The Detroit Edison Company
One Energy Plaza, Detroit, MI 48226-1279

10 CFR 52.79

November 20, 2009
NRC3-09-0035

Subject: Detroit Edison Company Response to NRC Request for Additional Information Letters No. 14 & 15

Figure 1.
Transect Used in Bretschneider Method

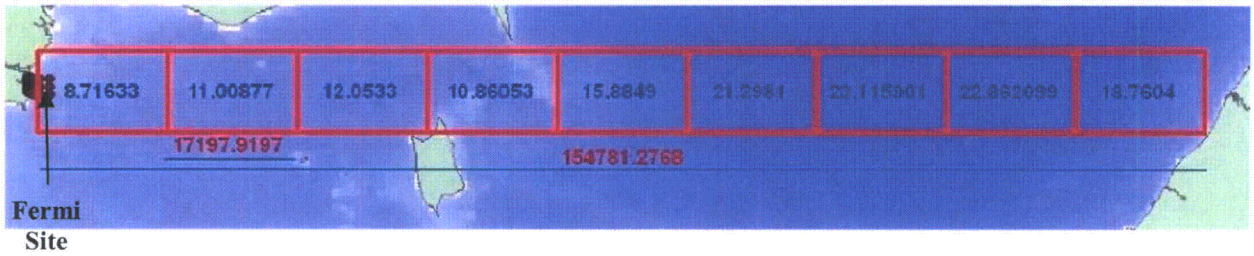
To meet the requirements of GDC 2, 10 CFR 52.17, and 10 CFR Part 100, and to support the staff's review of the application, estimates of the probable maximum storm surge are needed. Please provide a plan-view figure detailing the spatially distributed results of the STWAVE simulation from which the storm surge height of 3.14 m (10.3 ft) was derived. On the new figure, please note the locations of Fermi 3 and the point/model cell chosen to determine the storm surge height presented in the text.

Storm surge was not calculated using the STWAVE model. The STWAVE model was used to calculate wave heights in Lake Erie associated with 100 mph winds. The Bretschneider method was used to calculate storm surge (FSAR Ref 2.4-257). Using this method storm surge or wind setup is a function of wind speed, fetch and water depth. The Bretschneider method includes a procedure to account for an irregular lake bottom, which was used in the analysis. The Bretschneider method uses straight line fetches across an enclosed water body. A transect that represented the longest straight line across the lake that ended at the Fermi site was used in the analysis. It was assumed that the calculated storm surge applied to all points along the shoreline at the Fermi site.

Figure 1 below indicates the straight line transect used in the calculations and the depths for each segment. The Fermi site is depicted on Figure 1, depths are the average value in feet above the 100 year lake level.

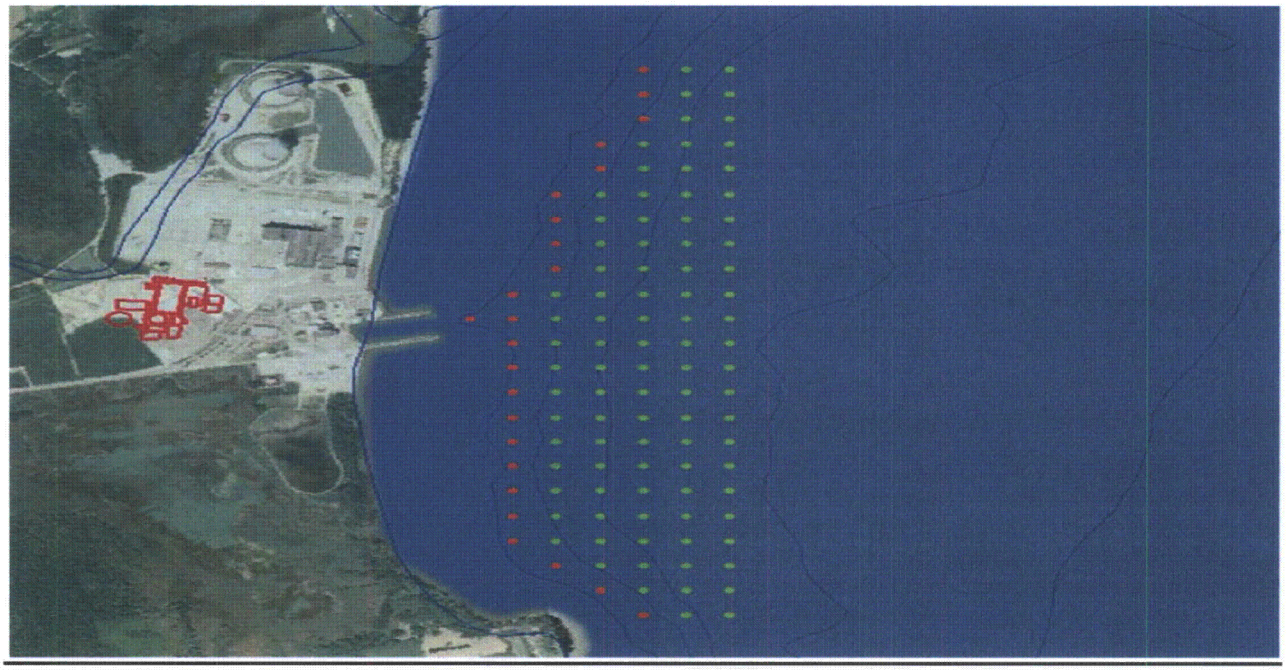
(2) Please provide a plan-view figure detailing the spatially distributed results of the STWAVE simulation from which the wave height of 3.92 (12.86 ft) was derived. On the figure, note the locations of Fermi 3 and the points that were chosen to determine the highest waves generated.

STWAVE modeling was conducted for the entire area of Lake Erie using a 100 m grid. The figure below shows the STWAVE grid points in the vicinity of the Fermi site. The red points represent the grid points that are closest to the shoreline in the Fermi area. STWAVE results for these locations were extracted from the model results. The attached table lists the x-y coordinates of the red points and the wave height and period at those locations. Data corresponding to the green points are not shown on the table because they are farther from shore. The green points are shown to indicate the scale of the grid used in the calculations.

The point closest to the shore (Object ID 24) does not have the highest wave height and was not used in the analysis. In order to be conservative, Object ID 11 (fourth red dot from the top of the fifth line from the right) with a wave height of 3.77 m and wave period of 11.1 sec was used in the analysis. There is only one other point (Object ID 3) with a higher wave height. However, a wave at Object ID 3 would move through Object ID 5 location as the wave moved toward the Fermi 3 site. Thewave height at Object ID 5 is 3.64 meters. Therefore, using the wave height at Object ID 11 is conservative.
